VCPS - New School

210 12th Street NE, Valley City, ND 58072
Project #: 24-028
Addendum 01
03/17/2026

SHEET
A111E

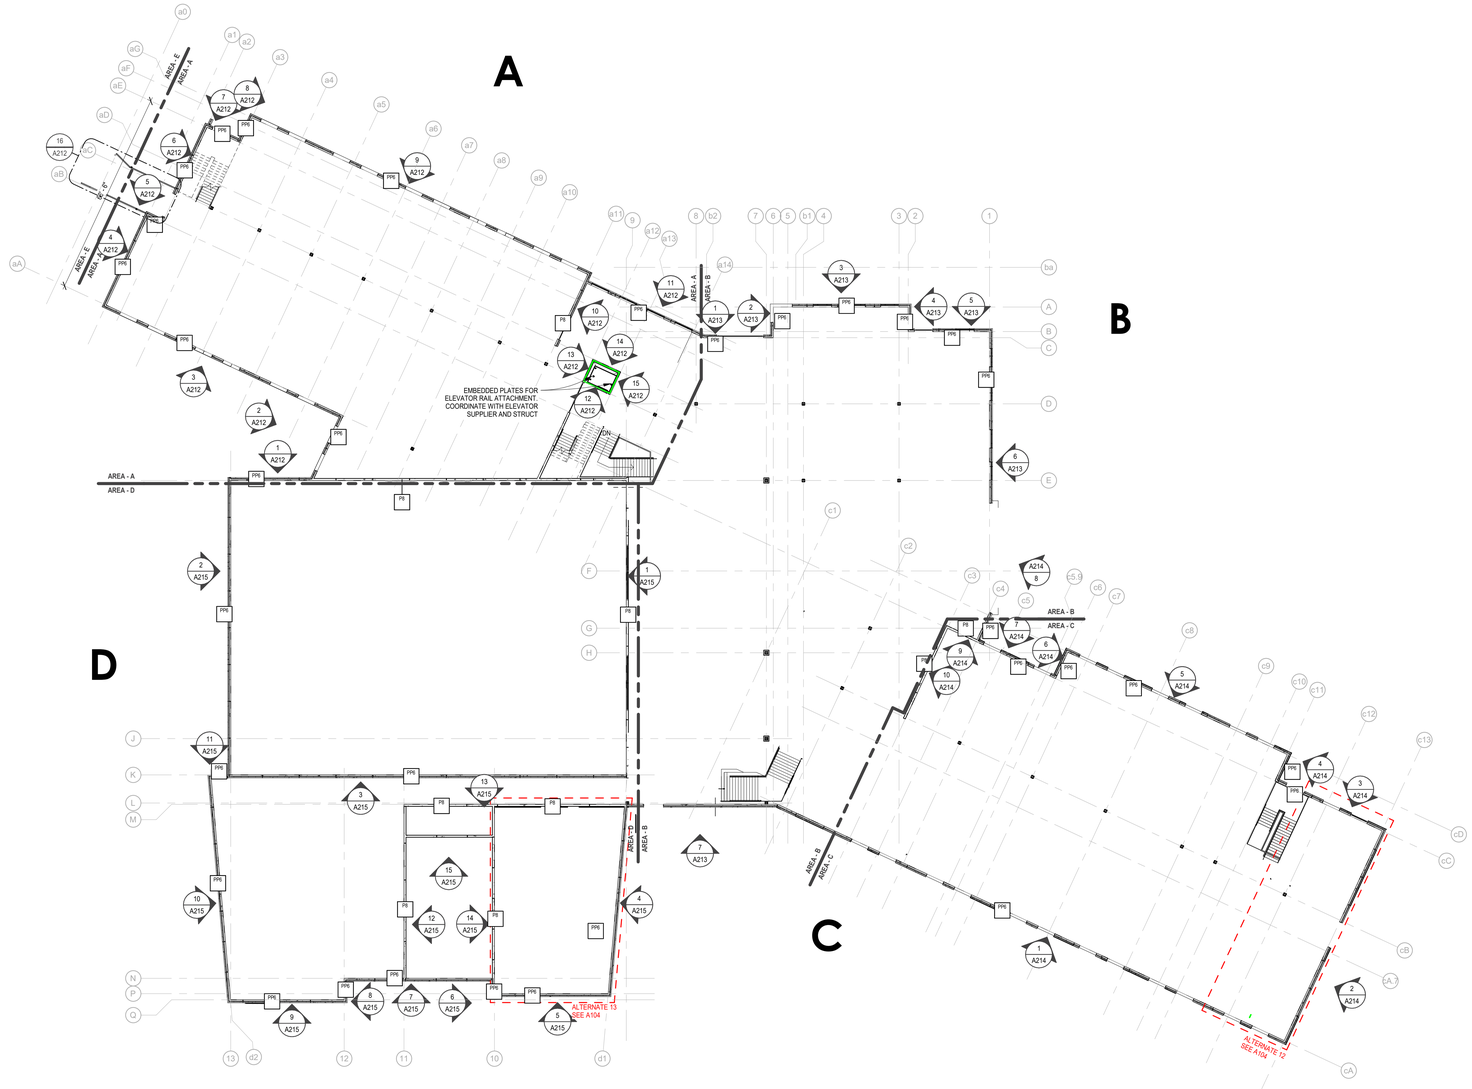
1. Adjusted soffit extents and added additional clarification at existing tie in.

SHEET
A211

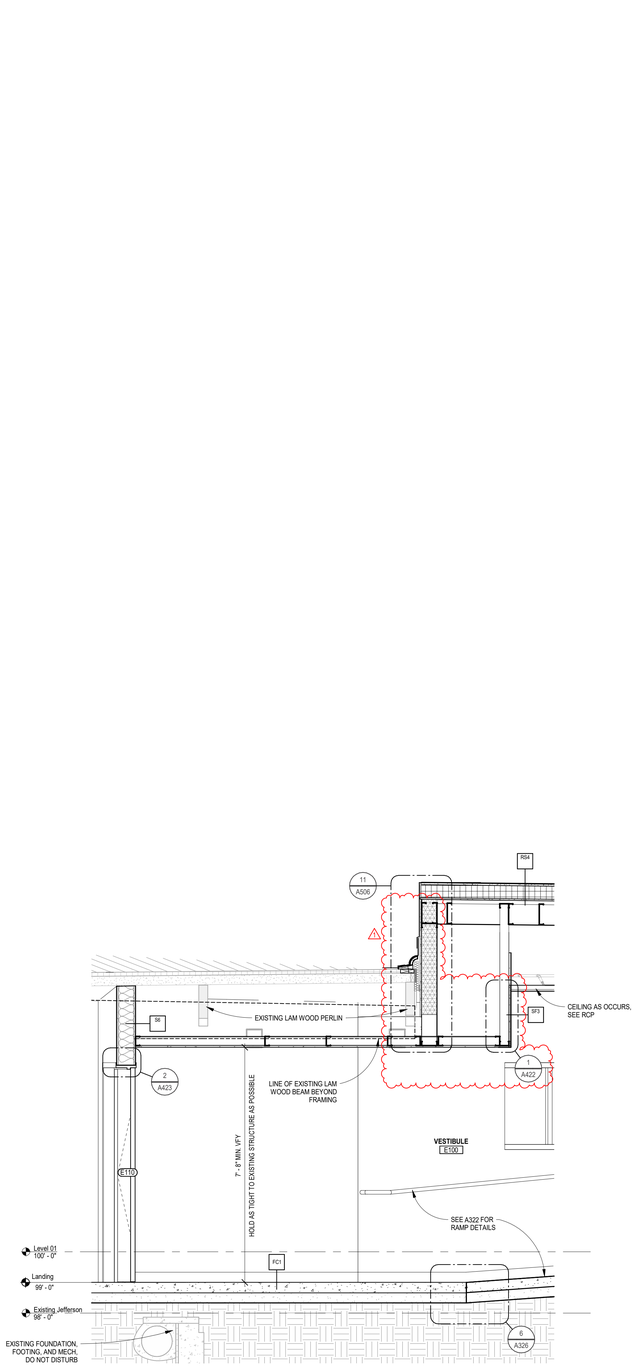
1. Added additional clarifications at wall assembly mockup.

11 A506 **Roof Connection at Jefferson**
1 1/2" = 1'-0"

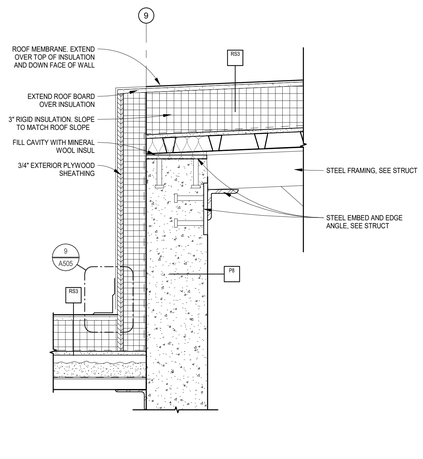
1. Aligned enlarged detail notes on 11/A506 with section at Jefferson connection.
2. Extended detail to show ceiling below.

2 A508 **Section at Exterior Column, Typ**

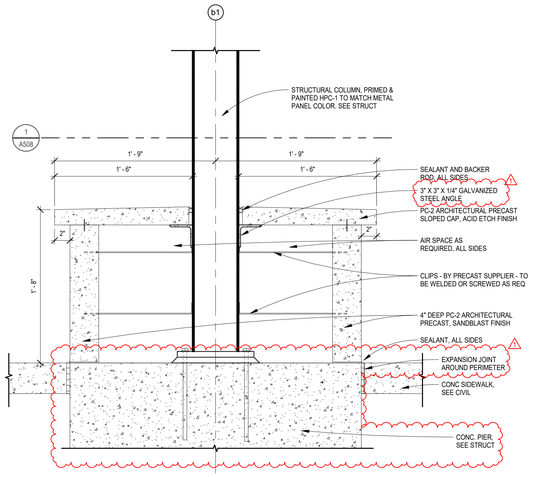
1. Clarified monument sign materials.
2. Adjusted retaining wall and decorative metal fence details.
3. Adjusted foundation and notes at exterior column detail 2/A508.
4. Adjusted the exterior column bases.

SHEET
E002

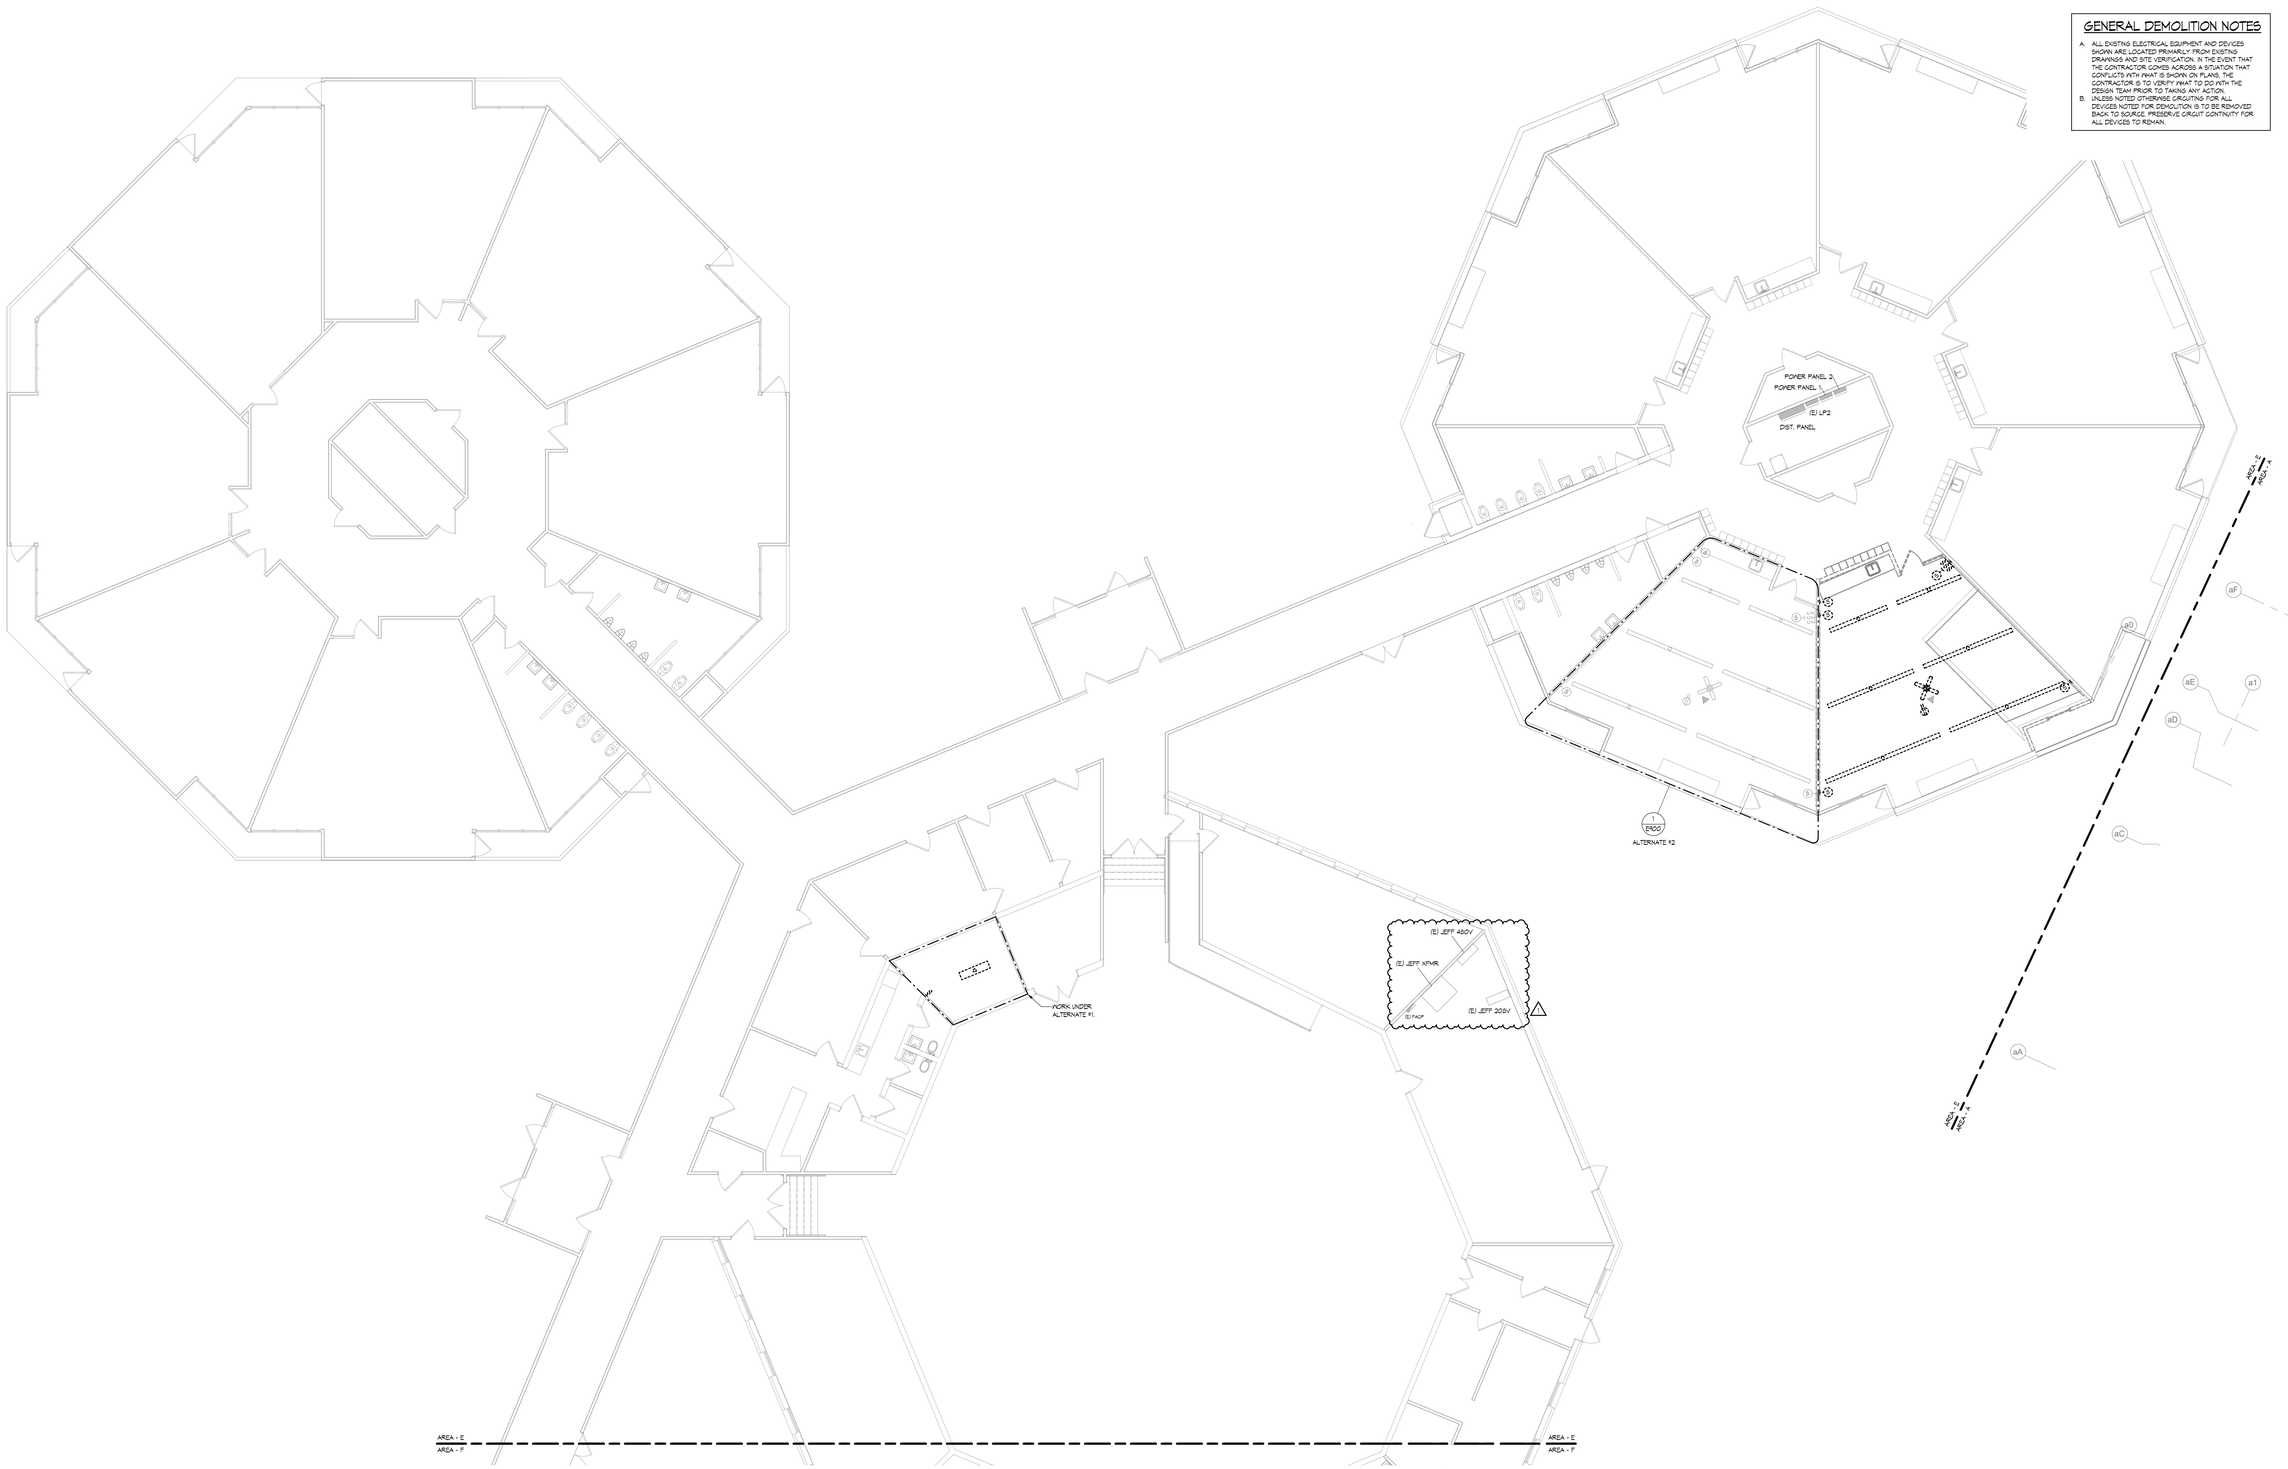
1. Added approximate underground routing for new Jefferson Elementary feed.
2. Added keynote W18.

SHEET
QF101

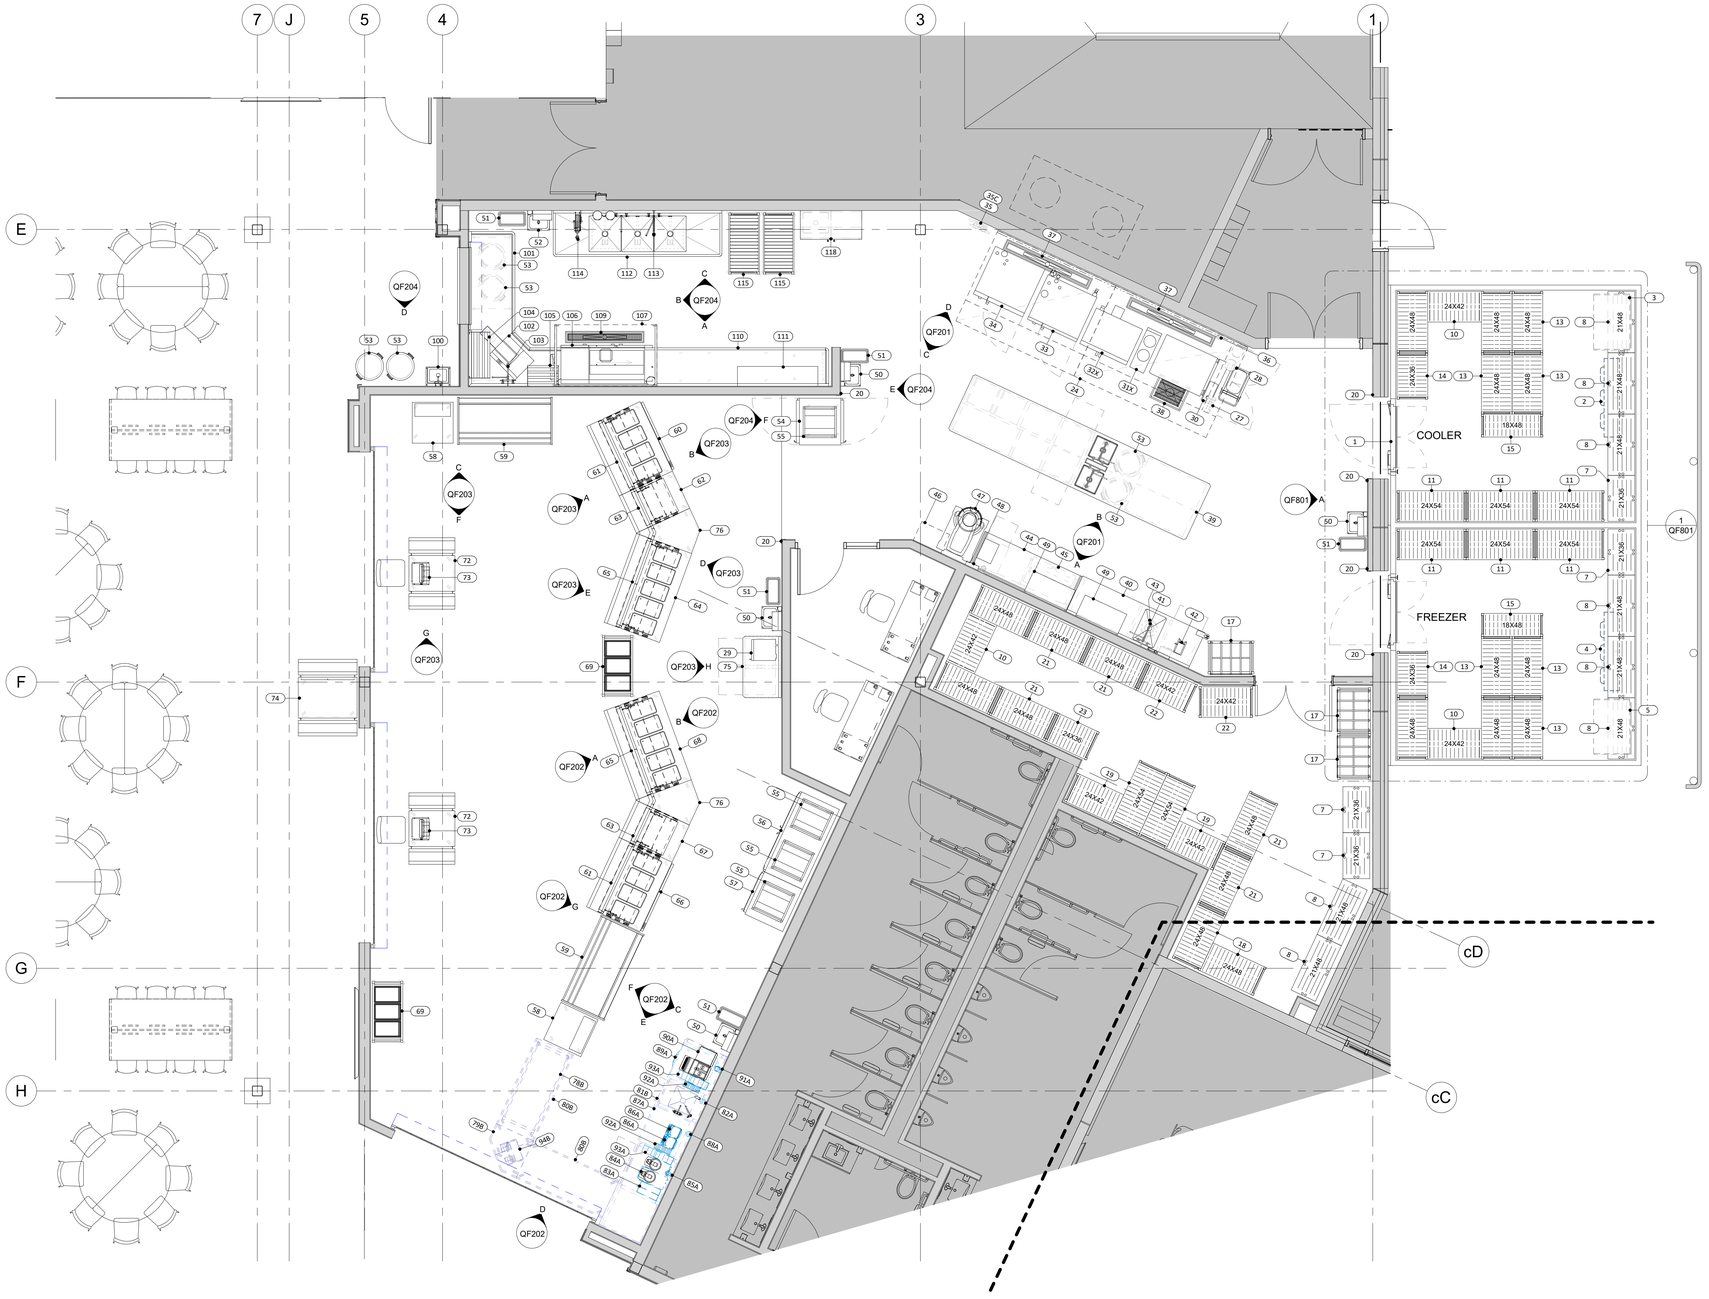
1. Status revised for alternates from ALT 8/ALT 9 to Alt 9A/ALT 9B

1 FOODSERVICE SPECIAL CONDITIONS PLAN
1/4" = 1'-0"

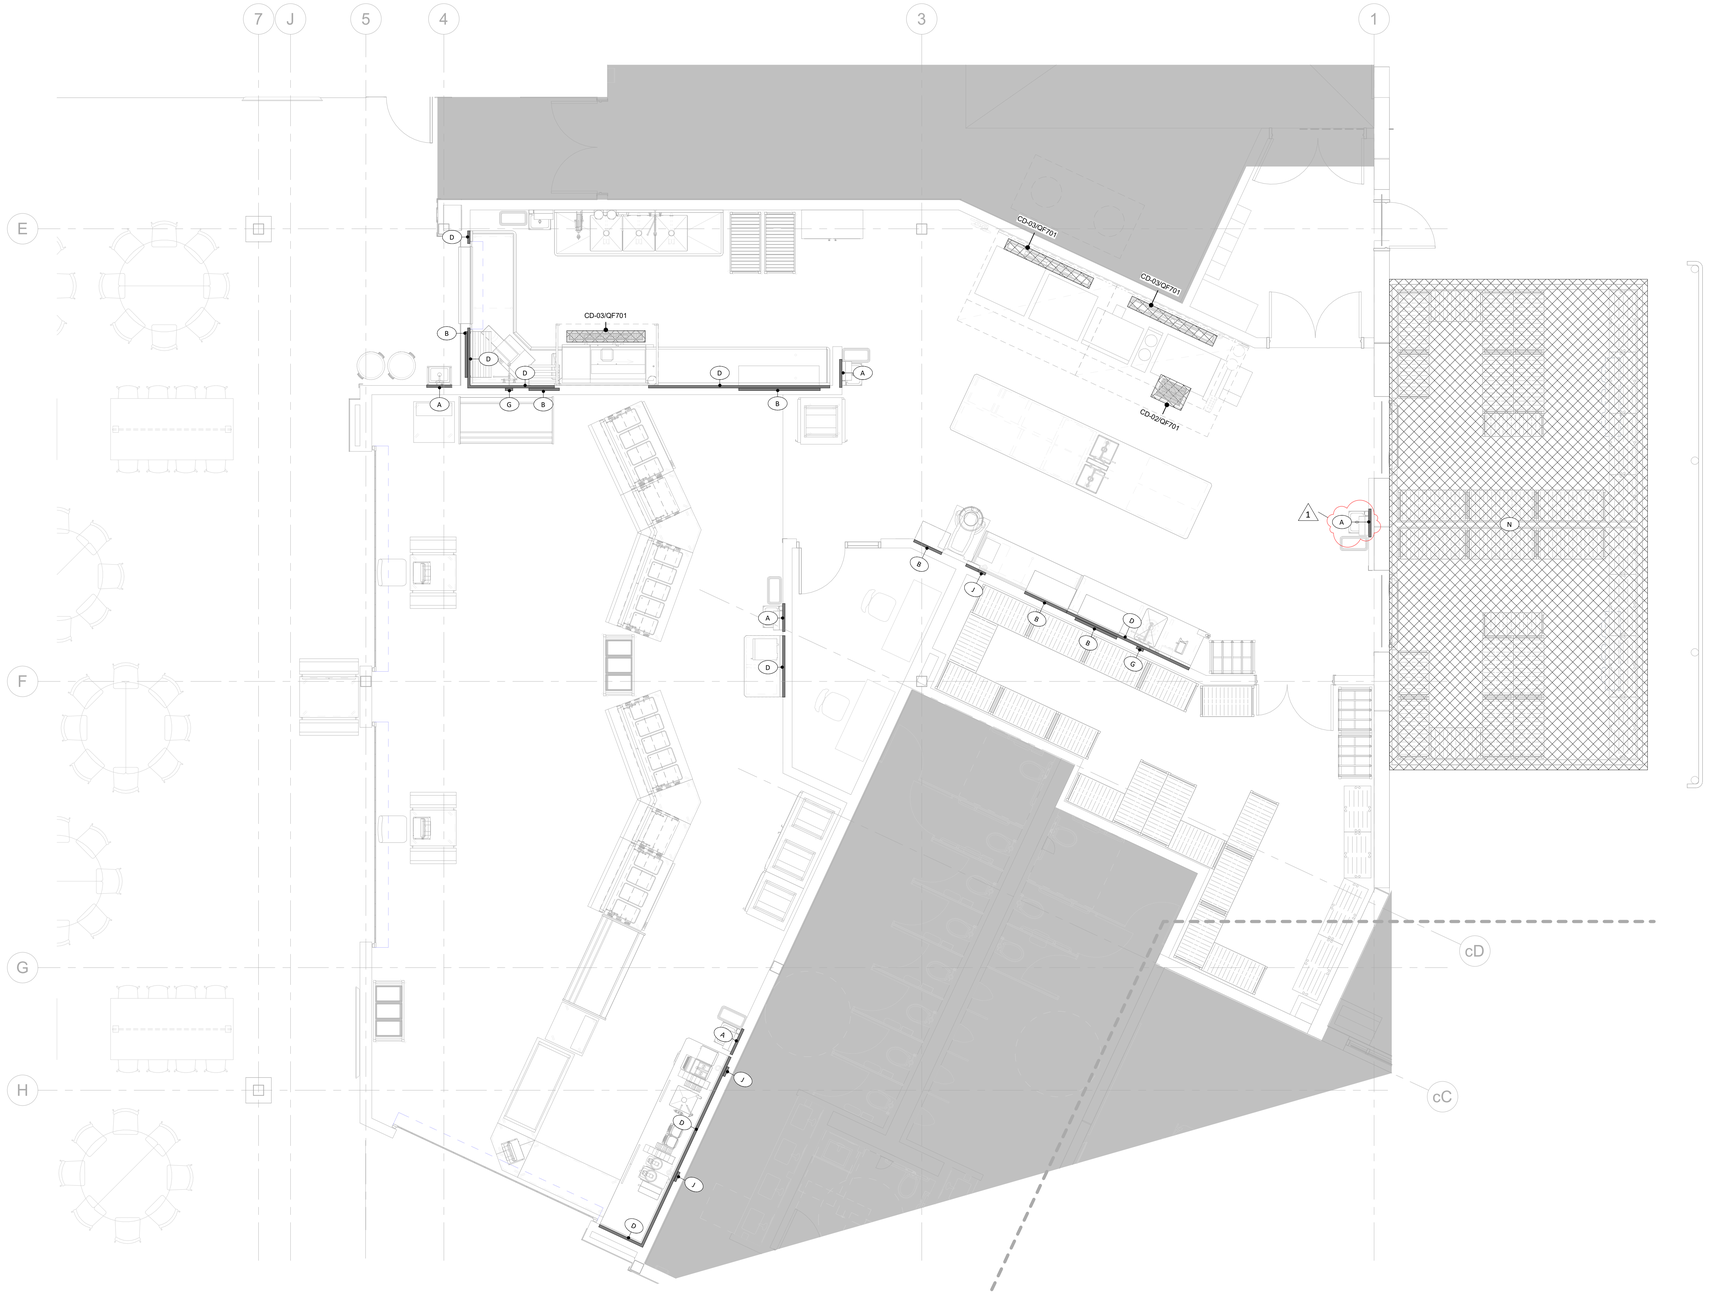
1. Wall backing added for hand sink by walk-in cooler/freezer

7 FD-07 - PREP SINK
NTS

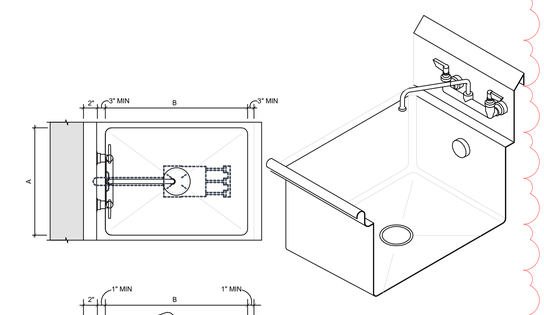
1. Details FD-07 & FD-08 revised sink bowl sizes
